ATTACHMENT 4

UNIT 1 – AREA WALK-BY CHECKLISTS

NO. SNCV061-RPT-01

A total of 75 Area Walk-bys have been completed.
The Checklists are provided within this Attachment.

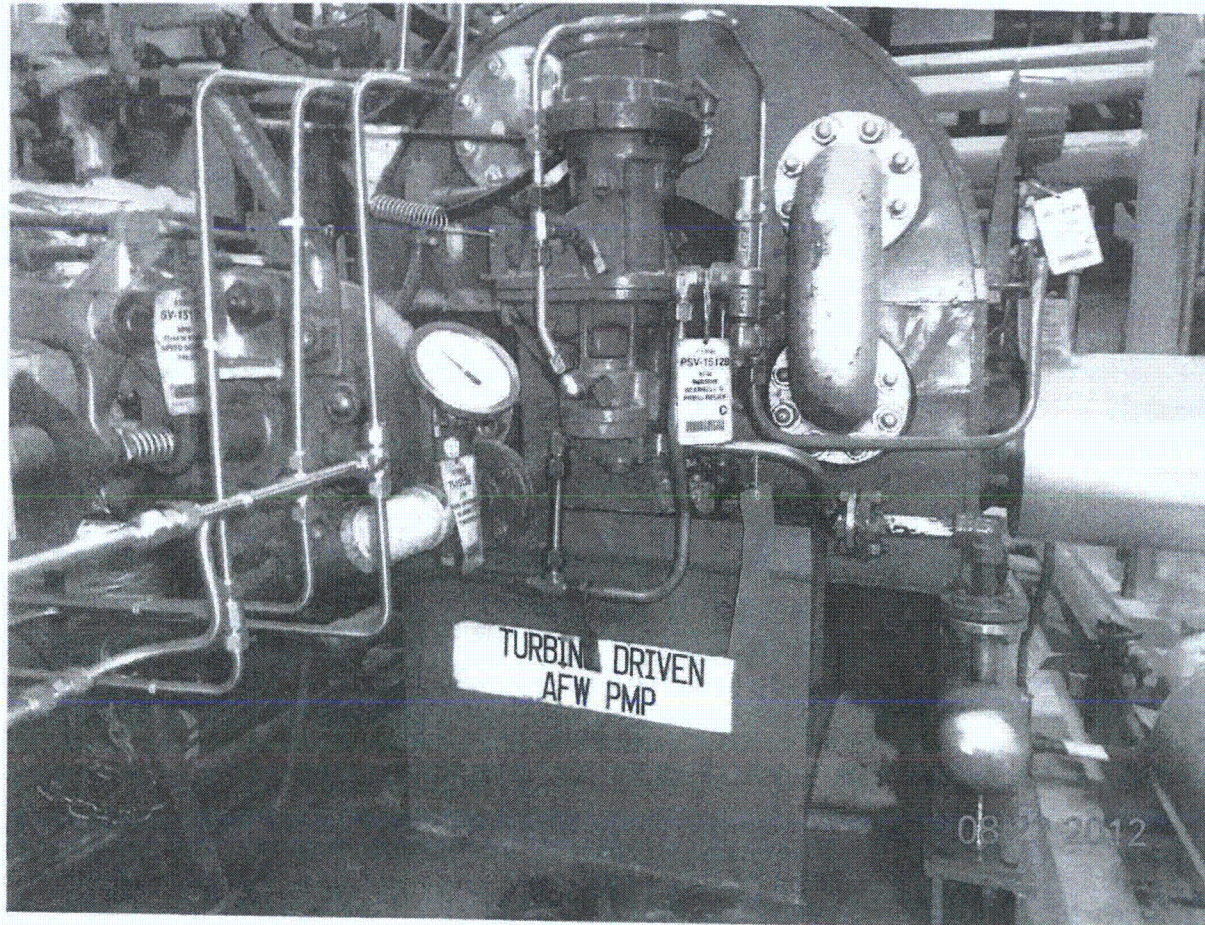
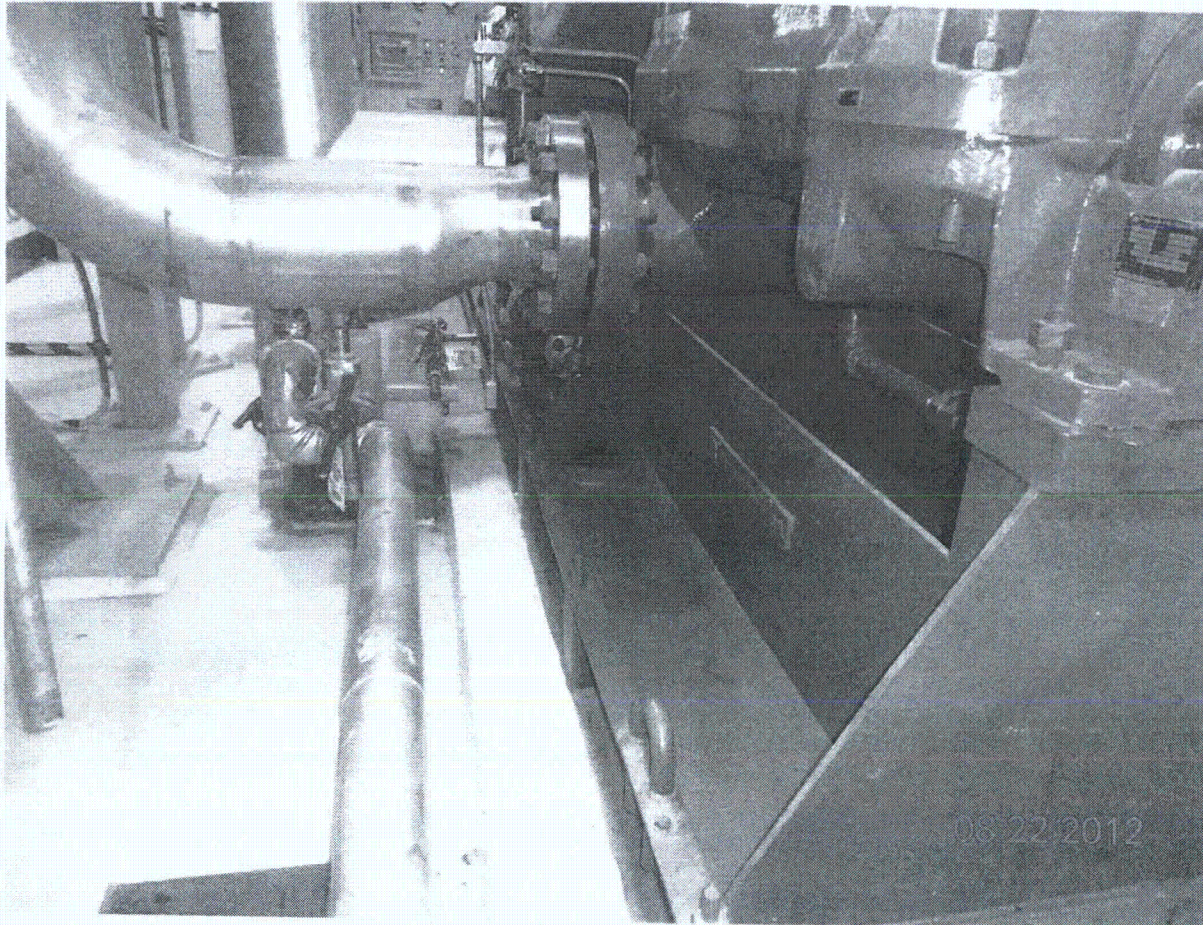
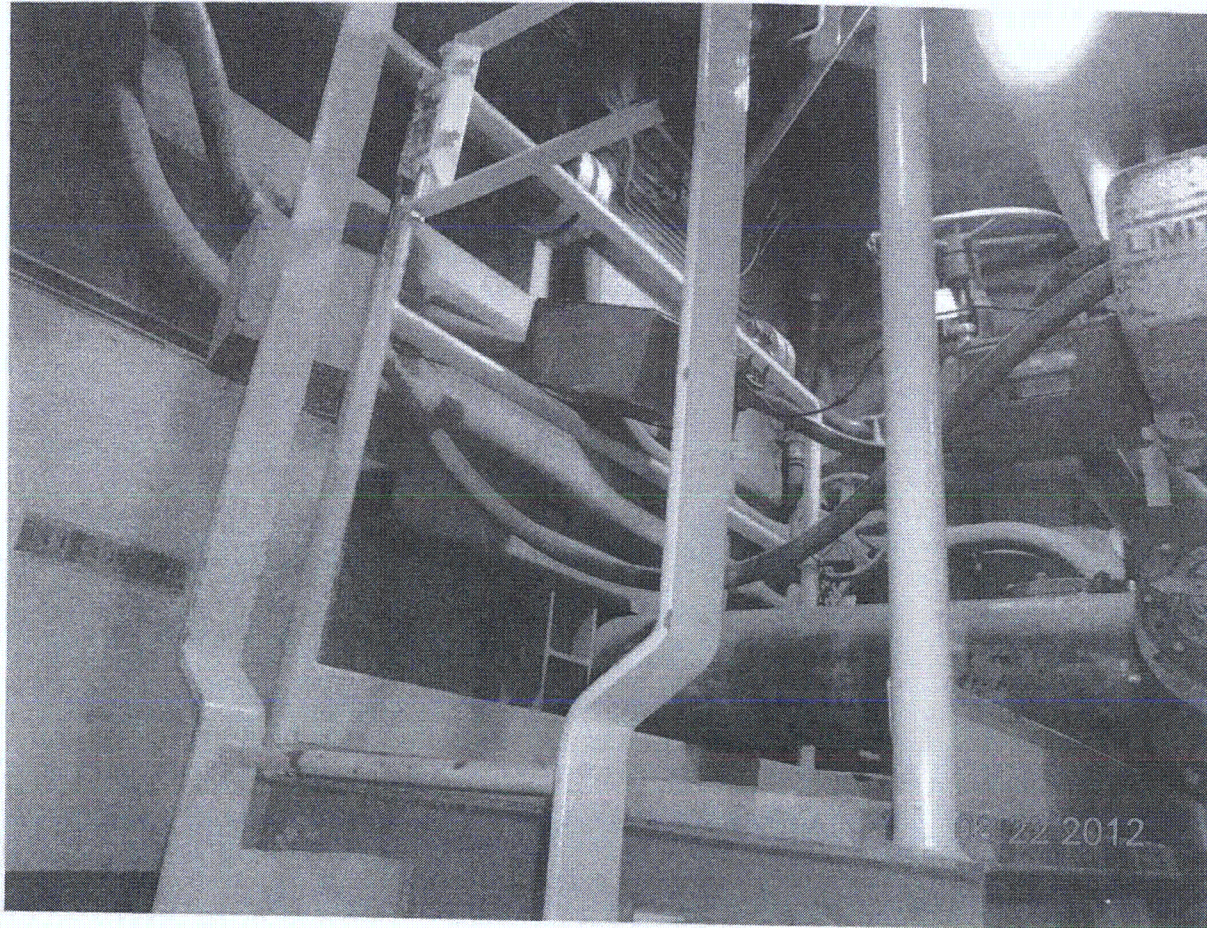
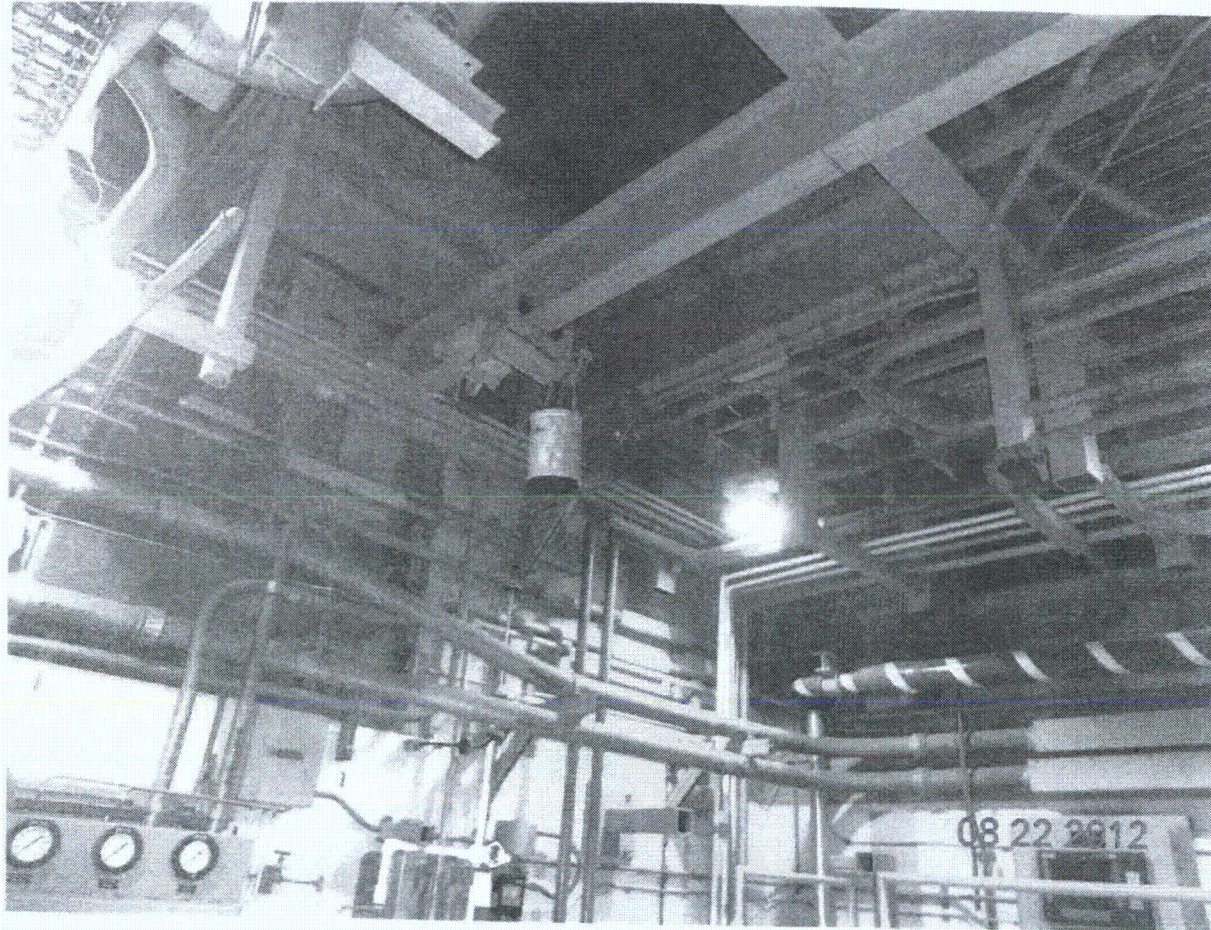
*Tool box near INCCAFM Aux FM Monitor is chained & secured ok.
Monorail chain bucket Overhead is secured and is acceptable.*

SWE observed a small electrical junction box above the access platform near valve 1-WV-5113. A flex conduit is connected between the junction box and valve. This junction box is supported by rigid conduit and which is rigidly supported from the wall. Since cantilever span for the box from the conduit support is small, there are no seismic concerns with the junction box. (See attached picture).

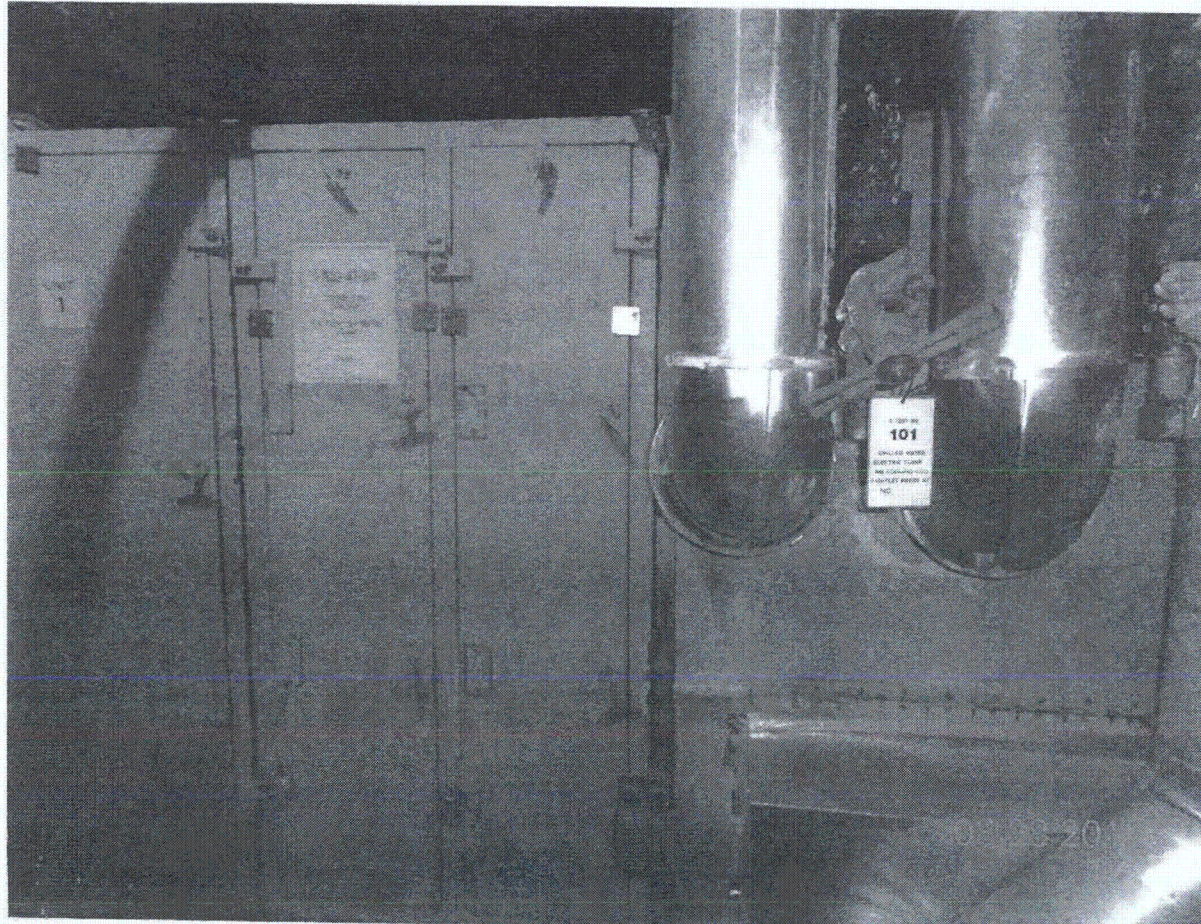
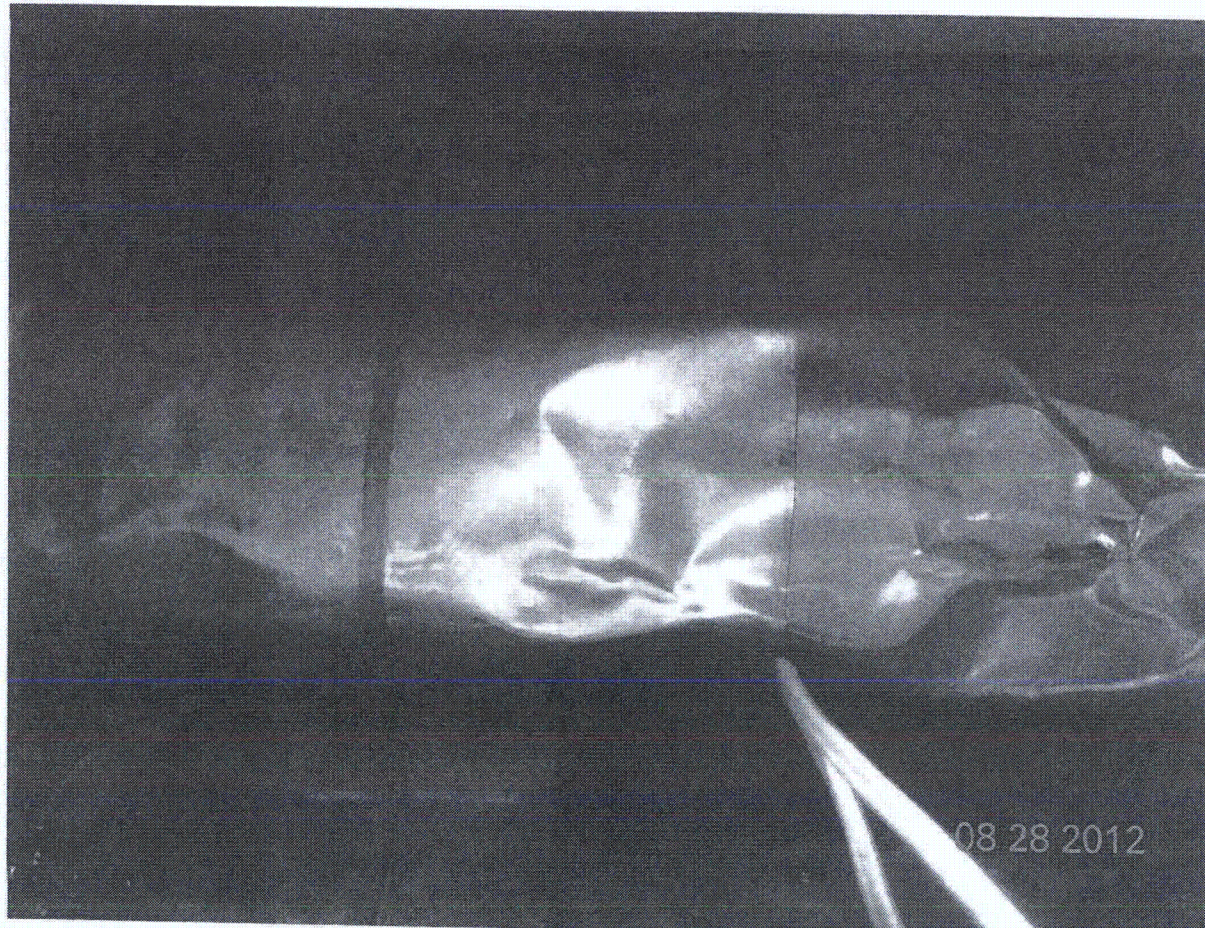
CR 509142
Hanger V-1591-027-H006 TB corrosion & Drain Valve
I-1591-04-046 corrosion under CR 509138 tracking
for further evaluation/action.
